BID ADDENDUM NO. 1

PROJECT NAME: PORT CHESTER HIGH SCHOOL ADDITIONS, ALTERATIONS
AND ATHLETIC FIELD

F&D PROJECT #: PCHS # 17295.03

DATE: February 14, 2019

4 ELEVATION - EXTERIOR
ANCHORING EXTERIOR CAST STONE
 SCALE: 1/2" = 1'-0"

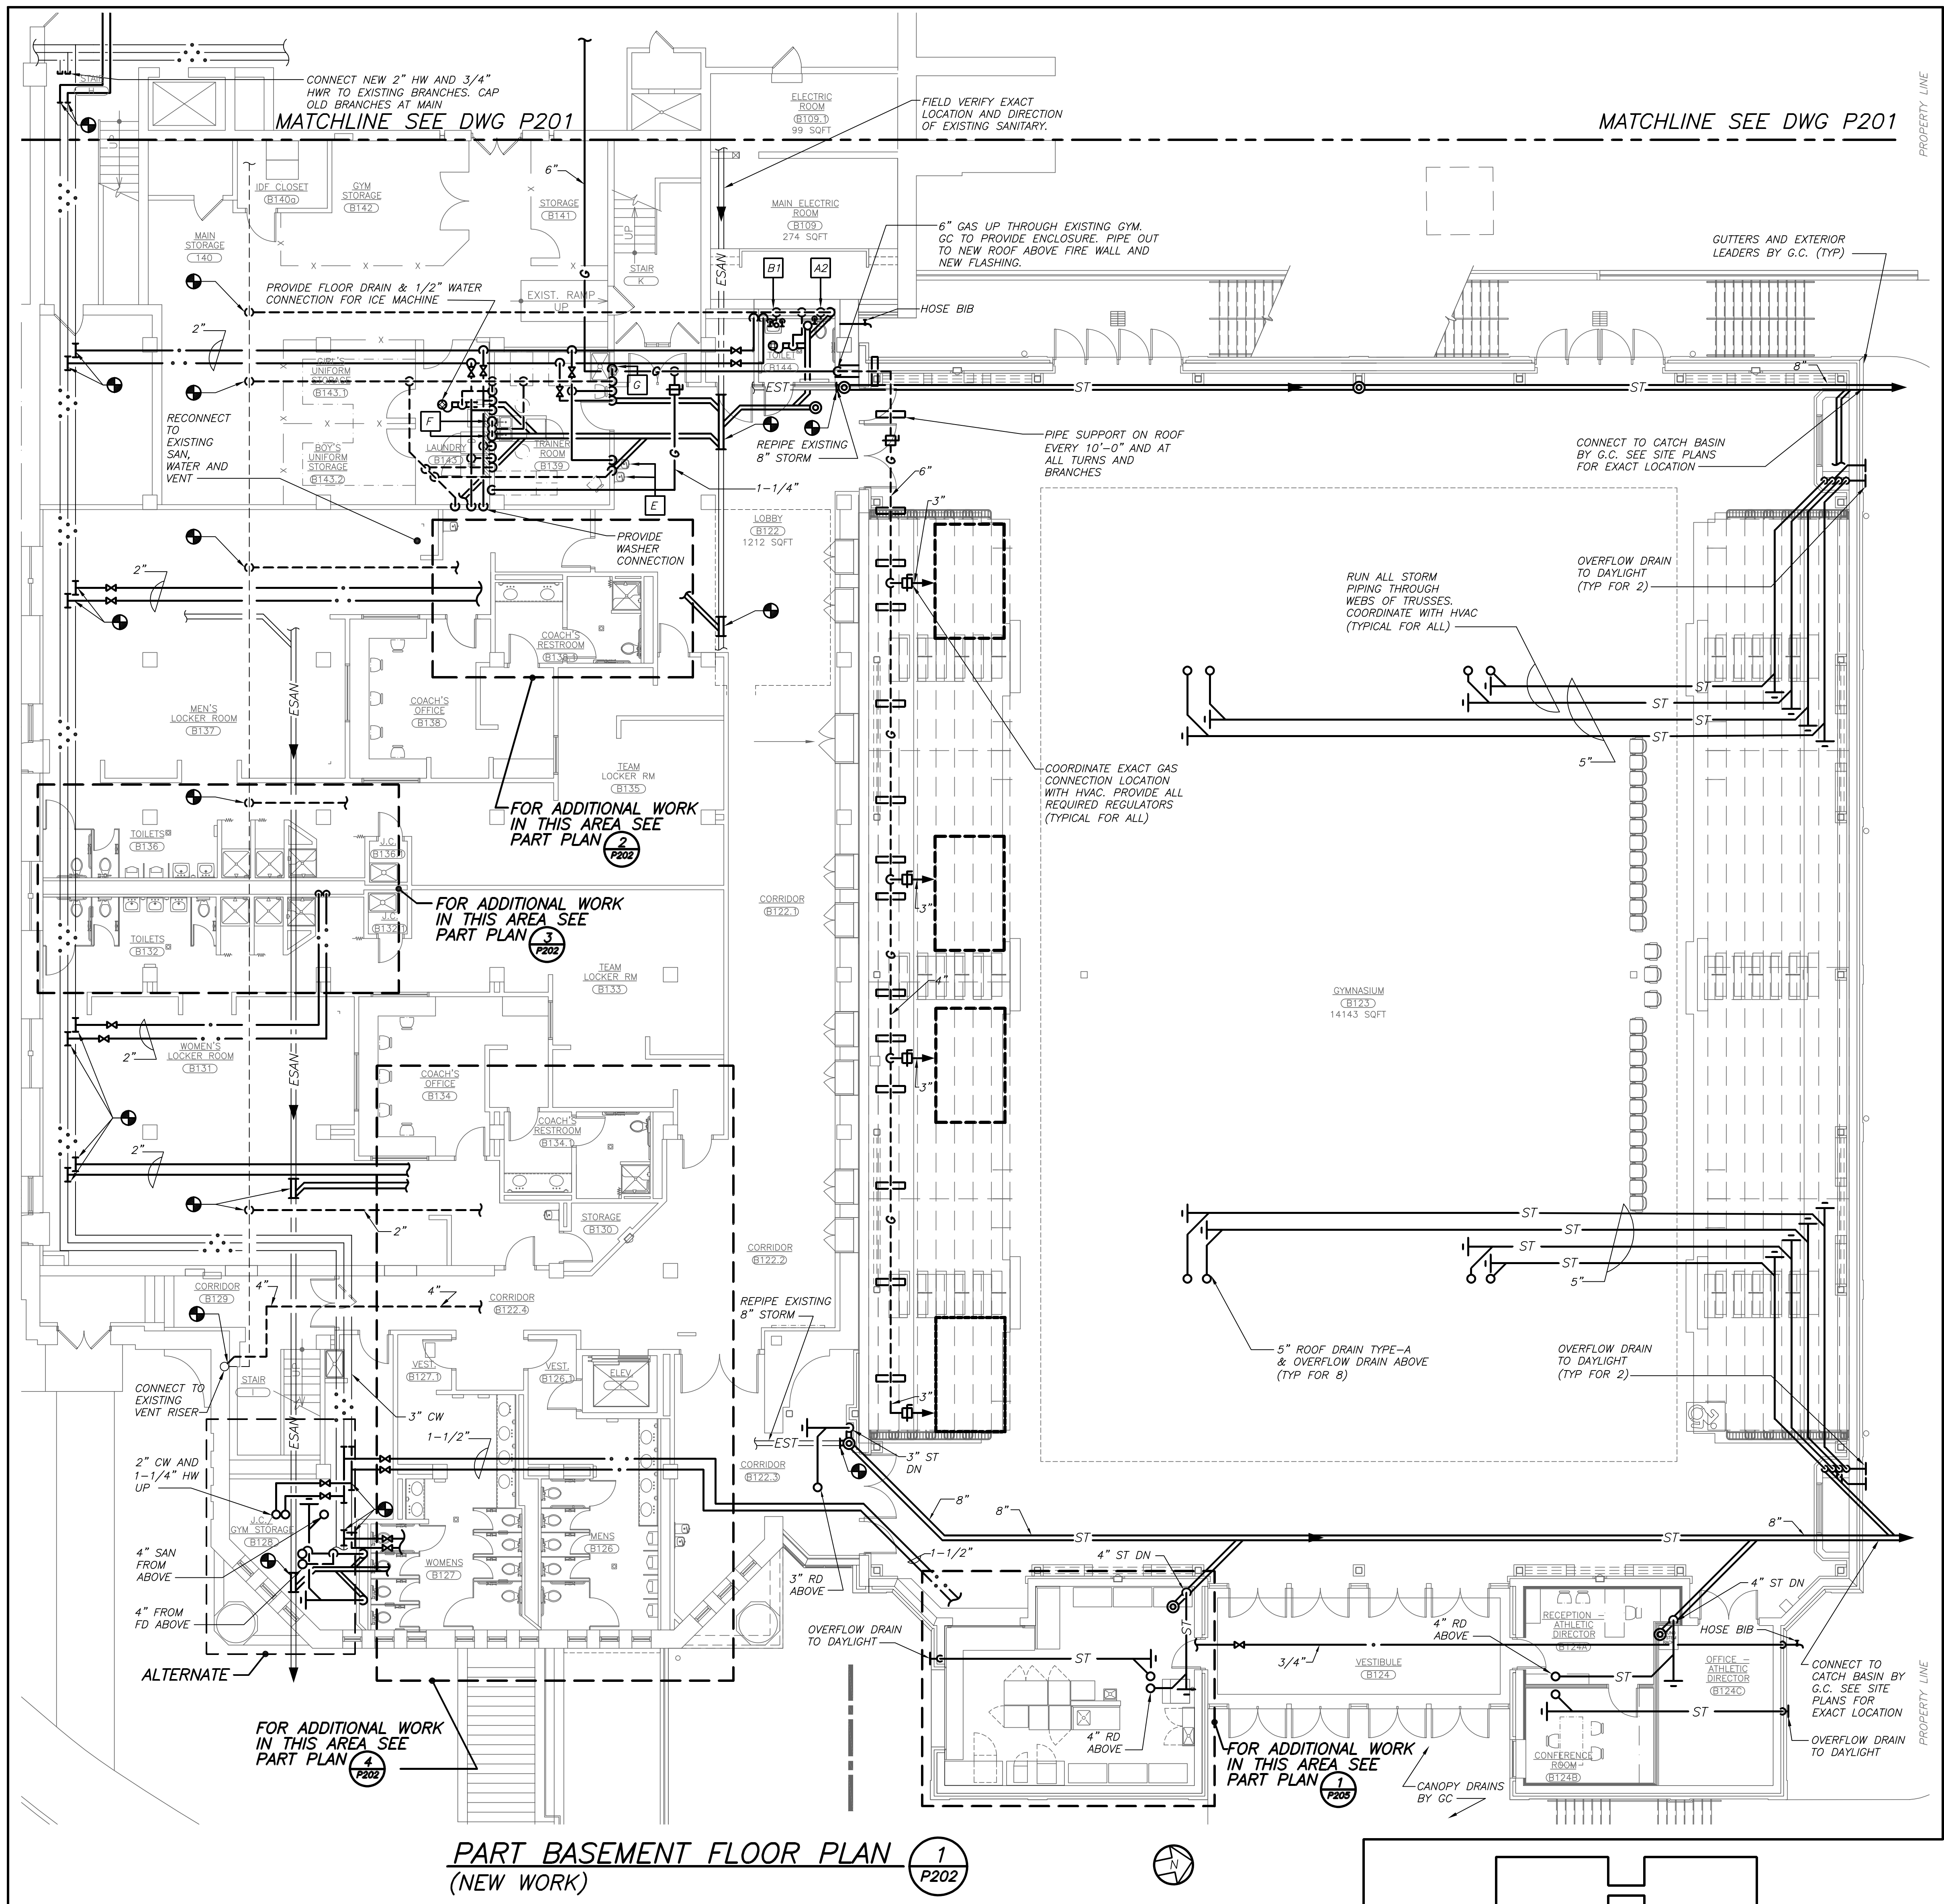
See Drawing A735 for precast stone detailing at round gymnasium windows. Note anchors and modified keystone locations/dimensions. (Drawing A735 issued as part of this addendum.)
